# Access Compliance Report

## Public Rights-of-Way

Intersection ID: 54455	Main Street: COLLINGHAM_DR	Cross Street: RUPELL_DR	Location: NE
ADA ID: 05BD046A5A65	Ramp Type: Perp	Initial Pass/Fail: Pass	Overall Compliance: No
Codes/Mitigation Info/Possible Solution		Field Measurements/Component Compliance	
Severity Score: 20.25

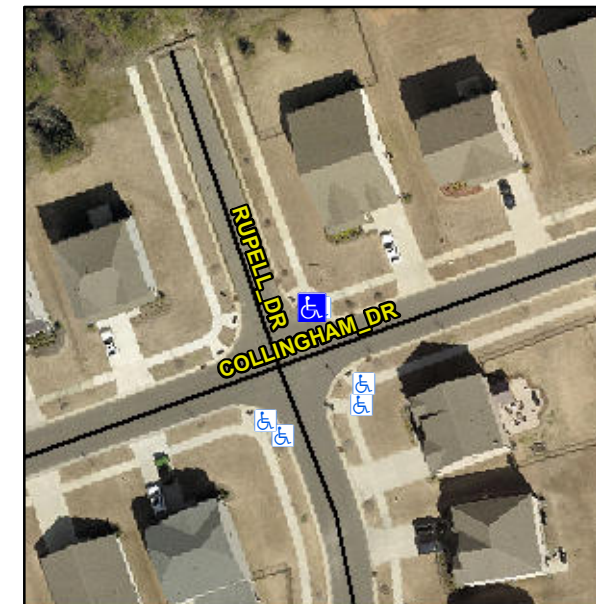
**Not Found, R304.5.3, R305.2,  
R302.7.2, R304.5.4**

Compliance	Description	Data	Compliance	Description	Data
N/A	Ramp Length (in)	95.0	Yes	Ramp Slope (%)	7.0
Yes	Ramp Width (in)	48.0	No	Ramp XSlope (%)	2.3
N/A	Flare Type LT	Sloped	N/A	Flare Type RT	N/A
N/A	Flare Slope LT (%)	5.0	Yes	Flare Slope RT (%)	2.8
N/A	Flare Traversable LT?	Yes	N/A	Flare Traversable RT?	Yes
Yes	Landing Length (in)	60.0	Yes	DWS Provided?	Yes
Yes	Landing Width (in)	48.0	Yes	DWS Contrast?	Yes
Yes	Landing Slope (%)	2.0	Yes	DWS Length (in)	24.0
Yes	Landing X Slope (%)	0.7	Yes	DWS Full Width?	Yes
N/A	Landing Curb? (Y/N)	No	No	DWS Offset (in)	3.0
N/A	Shared Landing?	No			
Yes	Gutter Ponding?	No	No	Gutter Slope (%)	5.8
No	Gutter Lip Ht (in)	1.0	Yes	Gutter X Slope (%)	0.7
N/A	Painted X Walk1?	No	N/A	Painted X Walk2?	N/A
	X Walk 1 Direction	To SW		X Walk 2 Direction	N/A
N/A	X Walk 1 Width (in)	N/A	N/A	X Walk 2 Width (in)	N/A
	X Walk 1 Slope (%)	1.6		X Walk 2 Slope (%)	N/A
	X Walk 1 X Slope (%)	0.7		X Walk 2 X Slope (%)	N/A

**Remove & Replace Entire Ramp.  
Remove & Replace Gutter.**
